# AutoGyro Certification Ltd Service Bulletin (CofA)

<b>Title: CavalonPro Stability and Vibration Reduction upgrade</b>		<b>Release date 05.05.2022</b>
<b>SB-C-007 Iss1</b>	<b>Related documents</b> Modification: MC-432 engine brace MC-425 teeter tower height change MC-384 mast bushes MC-382 New rotor head with higher pre rotation and Vne CCAR No.: None	<b>Compliance Category:</b>  <b>OPTIONAL</b> or <b>RECOMMENDED</b> or <b>MANDATORY</b>
<b>Applicability</b>		
<b>Aircraft type &amp; model:</b> All UK registered CavalonPros	<b>Aircraft serial Nos. affected:</b> All, as applicable	
The maintenance manual to be referenced is this stated or subsequent issue.		RSUK0335
<p>This form is the response from AutoGyro Certification Ltd either against a problem found in the product in service requiring a containment or rectification action, or as service information for aircraft modification incorporation. For help, contact RotorSport on 44(0)1588 505060, or email <a href="mailto:compliance@rotorsport.org">compliance@rotorsport.org</a>.</p> <p>The technical content of this document is approved under the authority of the UK CAA Design Organisation Approval Ref: <b>DAI/9917/06</b></p>

<b>Title:

### Keel Tube I to II upgrade

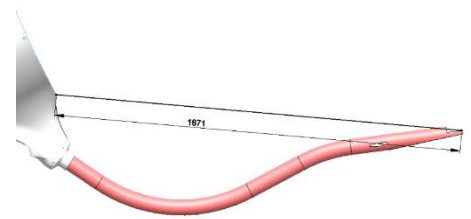
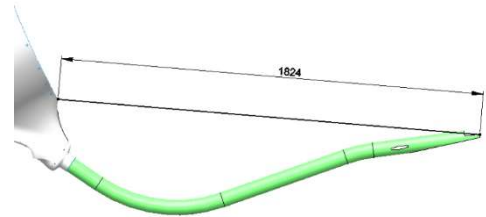
- 1 If the Cavalon is fitted with keel tube I (short version) it **MUST** be upgraded to keel tube II when upgrading from rotor head II to rotor head III.

Keel tube I – short (1671mm)

Keel tube II – long (1824mm)

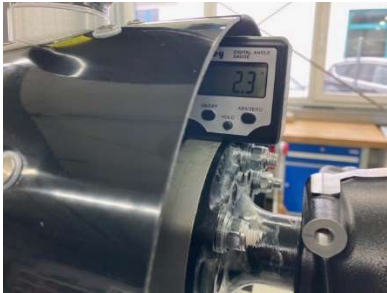
<b>Teeter Tower III to III.1 upgrade</b>		
<b><i>Removal of teeter tower and main crown gear assembly</i></b>		
1	Remove the rotor system in accordance with AMM job card 62-11-00 4-1.	
2	Remove the teeter tower and main crown gear assembly in accordance with AMM job card 62-20-00 8-1.	
3	Remove the 10 countersunk screws from the main crown gear and remove the crown gear from the teeter tower.	
<b><i>Re-assembly of teeter tower and main crown gear</i></b>		
4	Assemble the teeter tower III.1 to the main crown gear using 10 new M6x16 countersunk Torx and Loctite blue 243.	 <span style="border: 1px solid black; padding: 2px;">Teeter Tower III.1</span>
5	Assemble the teeter tower and main crown gear assembly to the rotor head in accordance with AMM job card 62-20-00 8-1.	
6	Re-assemble the rotor system in accordance with AMM job card 62-11-00 4-1. Note: Teeter block III is compatible with both teeter tower III and teeter tower III.1.

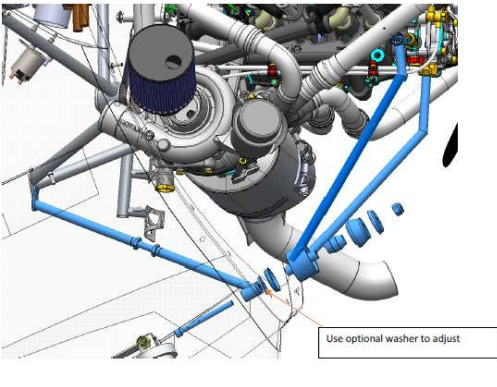
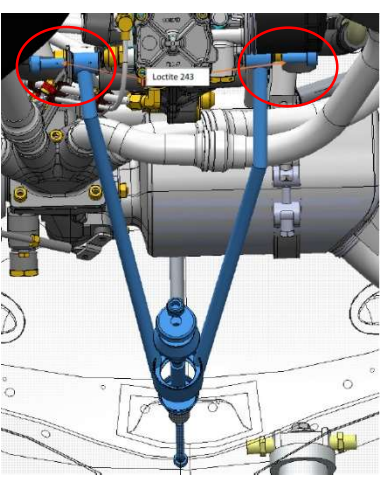
7	Rotate the support arm into position and mark the position of the hole onto the fuselage. There must be a minimum of 15mm material from the center of the hole to the upper edge of the composite. If this is not the case, use U10/30 washers to shim the support arm rearwards to achieve this. Drill a 10.5mm hole in the marked position.	
8	Assemble the support arm to the fuselage with any U10/30 packing washers required as previously noted in step 7 above and tighten. It may be necessary to assemble one or more U10/30 under the nut to compensate for bolt length. NOTE: The bolt is inserted from inside the engine bay to outside.	
9	Remove the support arm upper attachment bolts one at a time, apply Loctite blue 243 and re-assemble then tighten.

10	Re-assemble the right side fire wall and contour to fit around the engine support arm rubber.	
11	It is strongly recommended that the engine mounting rubbers be replaced as part of this modification. The engine cowlings can therefore be left removed.	
<b>Rotax 915</b>		
12	Assemble the spacer, support sleeve, rubbers and end-washers into the brace and rotate forwards so that the end cap rests on the fuselage.	
13	Mark the position of the forward spacer on the fire protection around its circumference. Move the brace to the rear and cut out any fire protection so that the end-washer sits against the composite of the engine compartment.	
14	Rotate the support arm into position and mark the position of the hole onto the fuselage. There must be a minimum of 15mm material from the center of the hole to the upper edge of the composite. If this is not the case, use U10/30 washers to shim the support arm rearwards to achieve this. Drill a 10.5mm hole in the marked position.

15	Loosely assemble the support arm to the fuselage with any U10/30 packing washers required as previously noted in the step above.	
16	If the aircraft has the earlier version of the keel tube reinforcement (47487) shown right, it should be removed using steps 18 to 20 as a guide. There should be a M6x35 bolt fitted (step 19), which can be re-used. Once the reinforcement arm is removed, proceed to step 20.	
<b>Installation of the keel tube reinforcement (915iS only)</b>		
17	If the aircraft does not have a keel tube reinforcement fitted, proceed as follows:	
18	Gain access to the lower engine mounting frame bolt by removing the PPC cover and intercom console in the cabin.	
19	Remove the M6x30 bolt and replace with M6x35.
